Site Name: <u>Progress Energy Asheville</u>	Date: <u>29 MAY 2009</u>
Unit Name: <u>1964 POND</u>	Operator's Name: <u>PROGRESS ENERGY</u>
Unit I.D.:	Hazard Potential Classification: <u>High</u> Significant Low
Inspector's Name: <u>FREDERIC SHMURAK / JUSTIN STORY</u>

Coal Combustion Waste (CCW)
Impoundment Inspection

Impoundment Name Progress Energy - Asheville 1964 PondImpoundment Company PROGRESS ENERGYEPA Region IVState Agency (Field Office) Address N/AName of Impoundment 1964 Pond

**ASHEVILLE STEAM ELECTRIC PLANT
2007 INDEPENDENT CONSULTANT INSPECTION
COOLING LAKE DAM AND ASH POND DAMS
TABLE OF CONTENTS**

Photograph 8: Cooling Lake Dam – spalling concrete on ogee spillway.

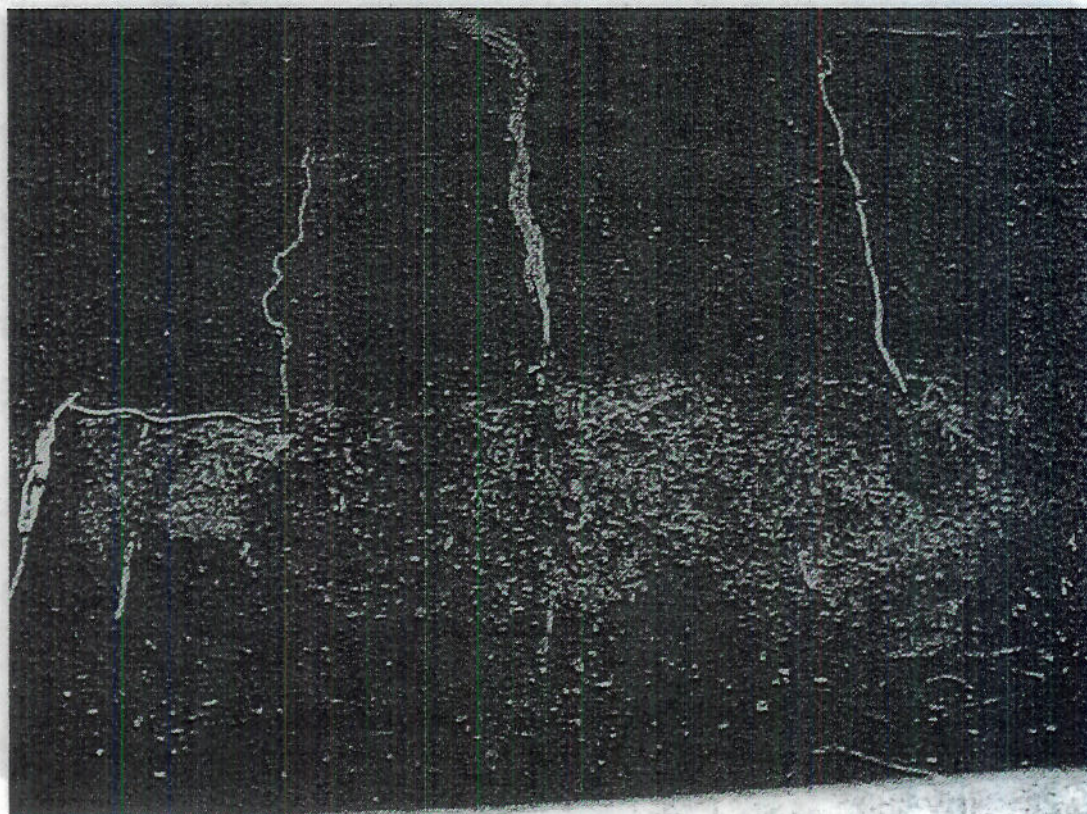
3. Repair the three areas of spalled concrete on the surface of the spillway slab.
4. Continue to remove accumulated sediment from behind the weir, as required.

Photograph 14: 1964 Ash Pond – seepage at toe of embankment, north of stilling basin.

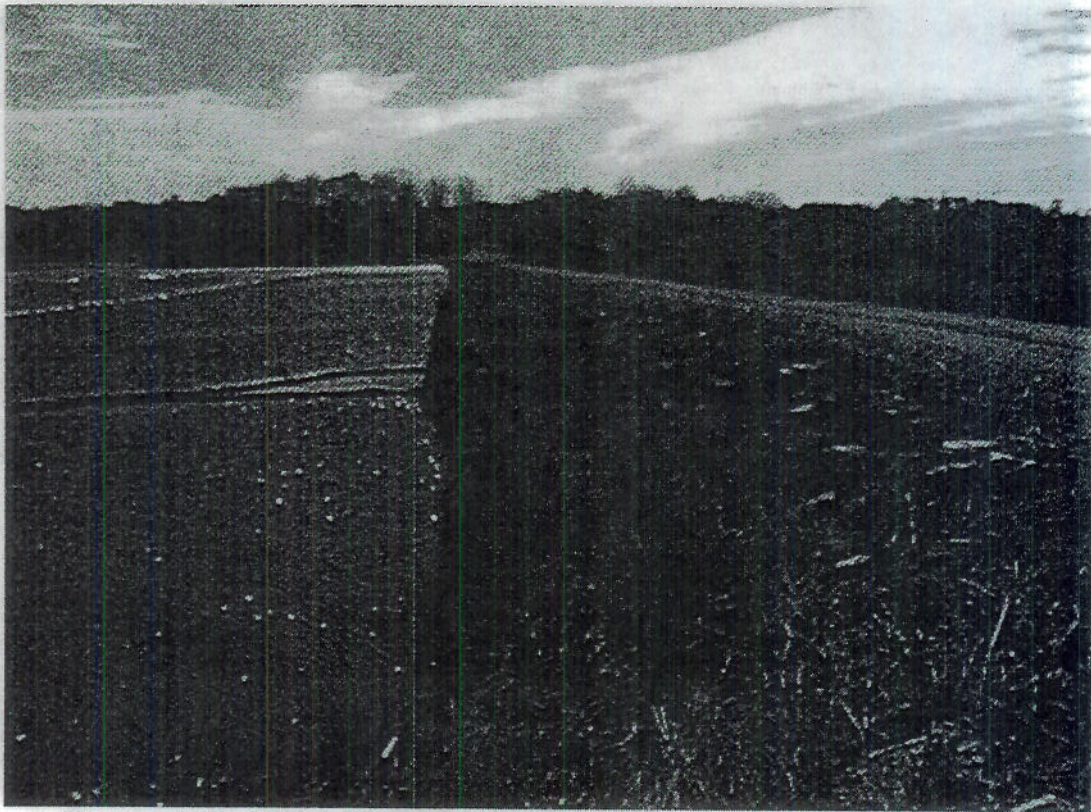
The natural seepage observed on the east abutment, near the downstream toe, was similar to that observed during previous inspections and is not considered a factor in dam safety or performance. Flow from the collector pipes installed in the sand blanket drain that passes through the seepage monitoring weir is clear (photograph 21). The weir and outflow channel are in good condition. Seepage flow monitoring records show no significant changes in flow rates.

Photograph 20: 1982 Ash Pond – rodent holes in downstream slope.

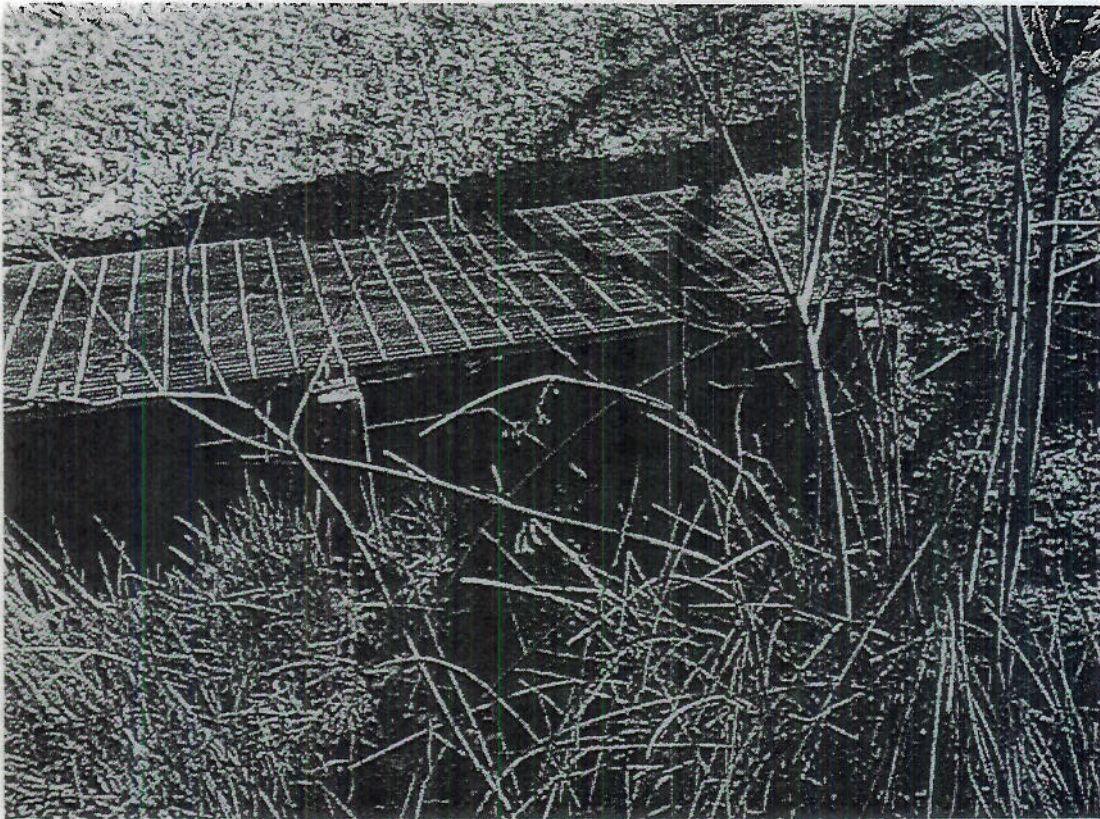
Annual inspections are conducted by a third-party professional engineering contractor. The engineering firms that conduct the inspections have expertise in geotechnical and civil engineering. Attached is the most recent annual inspection report summary. Actions taken or planned: Animal burrows noted on western portion of embankment. Animals should be removed and the burrows backfilled with tamped earth.
